REMARKS

Corrected Drawings

ANNOTATED MARKED-UP DRAWINGS

26/46

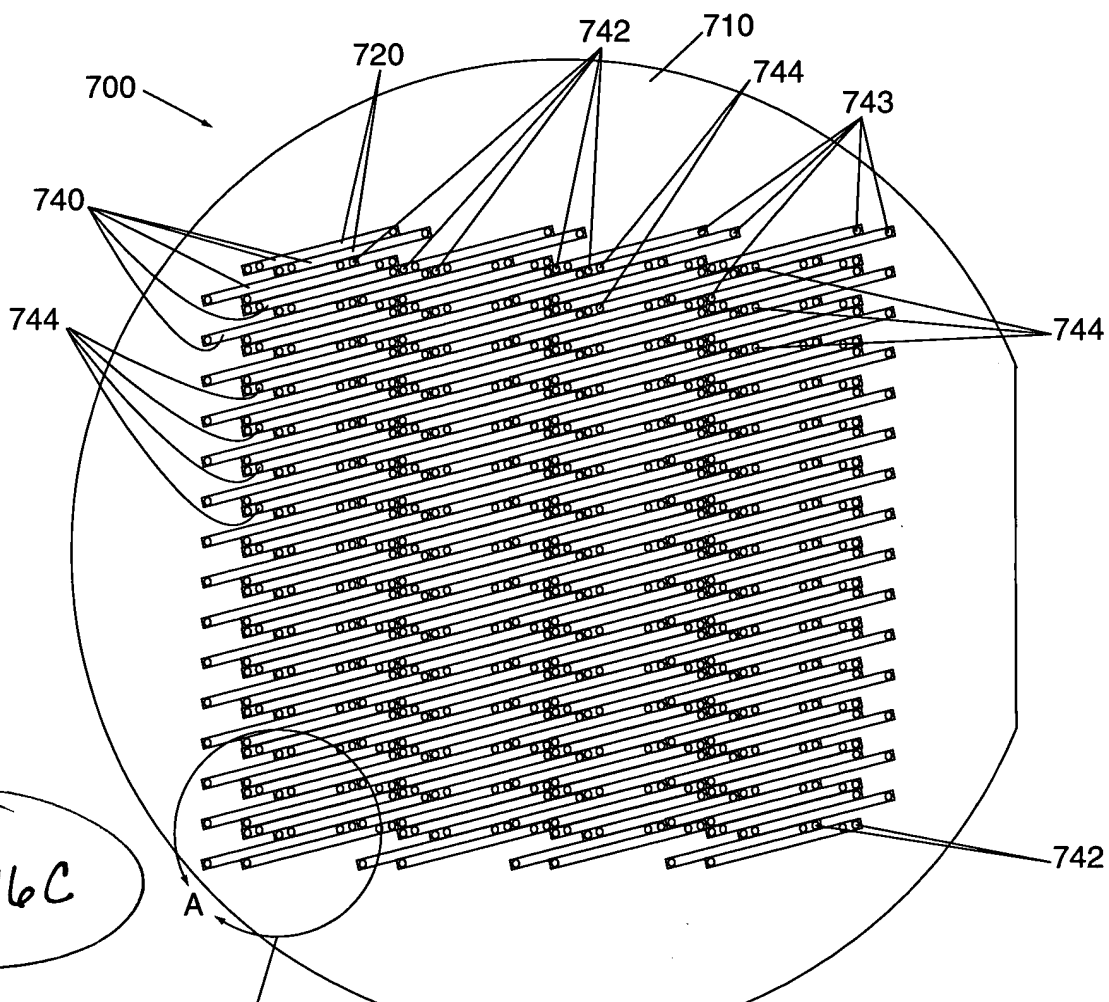
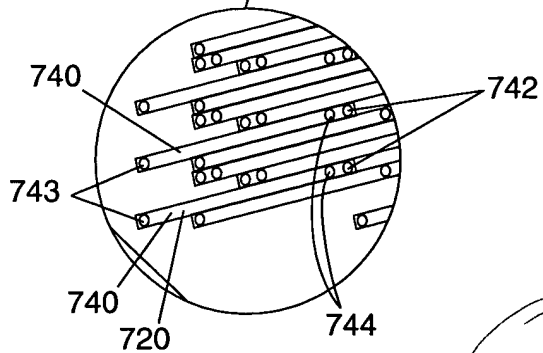
Applicants have submitted new Replacement Sheet for drawing sheet 26/46 that corrects the formal drawings – separately labeling the two views thereon as Figure 16C and Figure 16C-1. A marked-up version showing the changes to this sheet is also attached hereto labeled as “Annotated Marked-Up Drawings”. Applicants are also submitting a complete set of formal drawings, filed herewith, which include the corrected version of sheet 26/46. No new matter has been added.

Applicants have amended the specification to appropriately refer to each of the two views as now shown on replacement sheet 26/46 (submitted herewith and including Figure 16C and Figure 16C-1). Applicants have also amended the Specification to include the new corrected drawing sheet 26/46. No new matter has been added.
